**ZONING AMENDMENT,
PLANNED UNIT DEVELOPMENT &
SUBDIVISION STAFF REPORT**

Date: December 4, 2003

The Reserve @ Knollwood & Girby Roads

SITE PLAN

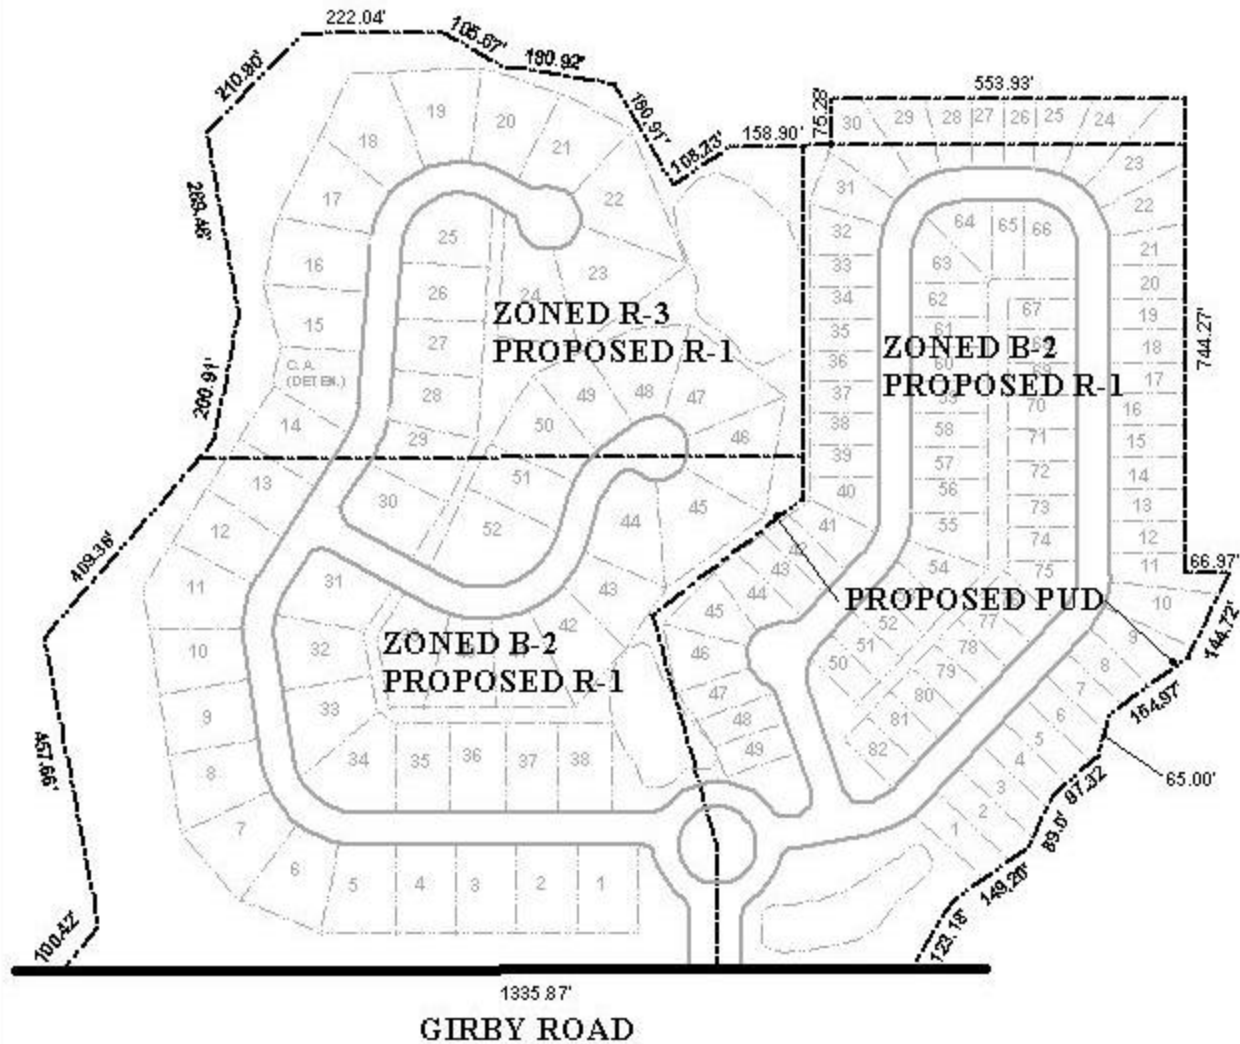
In terms of reduced setbacks, a 15-foot front yard setback is proposed and would be typical of many R-1 PUD approvals. However, as illustrated on the site plan, 2-foot and 8-foot side yard setbacks are proposed. This is unconventional; nevertheless, these

setbacks would ensure a minimum 10-feet between structures. It should be noted that Building Code may require a greater setback (3-feet) if windows are proposed. Therefore, in an effort to provide a modicum of flexibility, allowing a change in side setbacks, but maintaining a minimum separation of 10-feet between structures, could be allowed.

The site fronts Girby Road, a planned major street, which has an existing right-of-way of 80-feet; therefore, the dedication of adequate right-of-way to provide 50-feet from the centerline should be required. Additionally, a note should be placed on the final plat stating that access is limited to the one entrance road for the development.

Planned Unit Development Based upon the preceding, this application is recommended for approval subject to the following conditions: 1) full compliance with the City Engineering Comments (strict adherence to all stormwater ordinance requirements, provision of drainage easements to encompass 100 year flood area, compliance with all stormwater and flood control ordinances, any work performed in the right of way will require a right of way permit); 2) the approval of all federal, state and local agencies; 3) that a minimum of 10-feet of separation be provided between buildings; and 4) full compliance with all municipal codes and ordinances.

DETAIL SITE PLAN

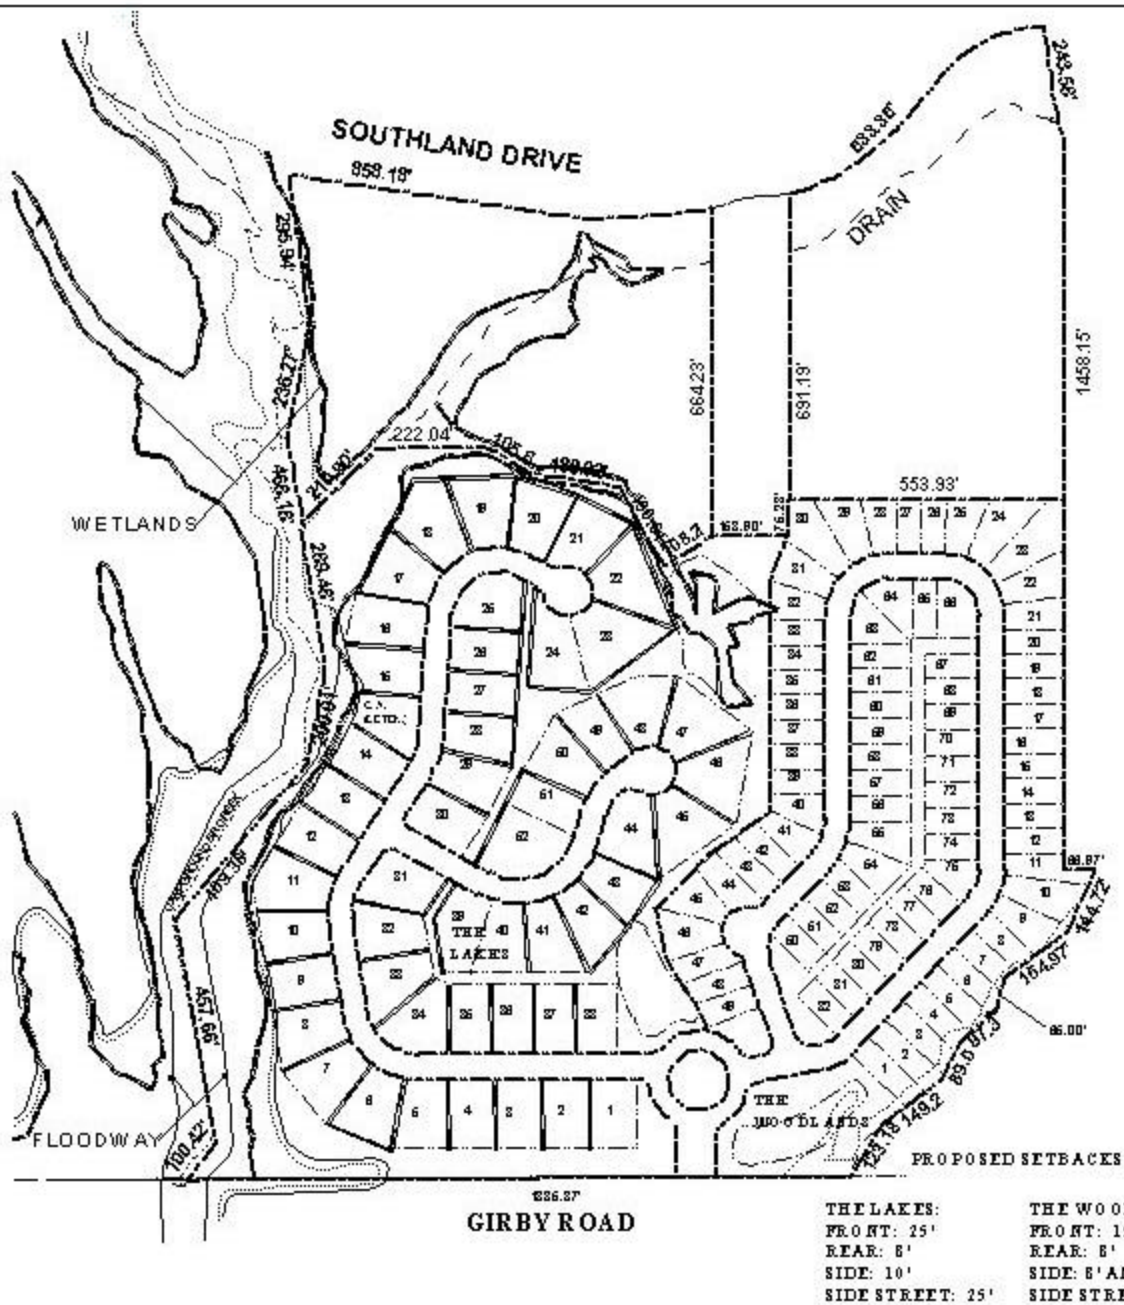
The site will actually consist of two different styles of R-1 development. The western portion—The Lakes will comply with standard R-1 requirements in terms of setbacks and site coverage; the eastern portion—The Woodlands, will have reduced lot sizes, and setbacks, with increased site coverage. However, it should be noted that the overall site has adequate open space that more than provides 7,200 square feet per lot, and is thus in compliance with R-1 density requirements.

In terms of the subdivision request, many of the lots in the Woodlands are less than 50-feet wide and contain less than 7,200 square feet, thus a waiver of Section V.D.2., would be required. Additionally, there are many large common areas within the development, and the placement of a note on the final plat stating that the maintenance thereof is the responsibility of the property owners would also be required.

Subdivision: With modifications, the plat will meet the minimum requirements of the Subdivision Regulations and is recommended for Tentative Approval subject to the following conditions: 1) full compliance with the City Engineering Comments (strict adherence to all stormwater ordinance requirements, provision of drainage easements to encompass 100 year flood area, compliance with all stormwater and flood control ordinances, any work performed in the right of way will require a right of way permit); 2) dedication of any necessary right-of-way to provide 50-feet from the centerline of Girby Road, a planned major street; 3) that the site be limited to the one entrance road as shown on the plat submitted; 4) that a minimum of 10-feet of separation be provided between buildings); 5) the approval of all federal, state and local agencies; and 6) full compliance with all municipal codes and ordinances.
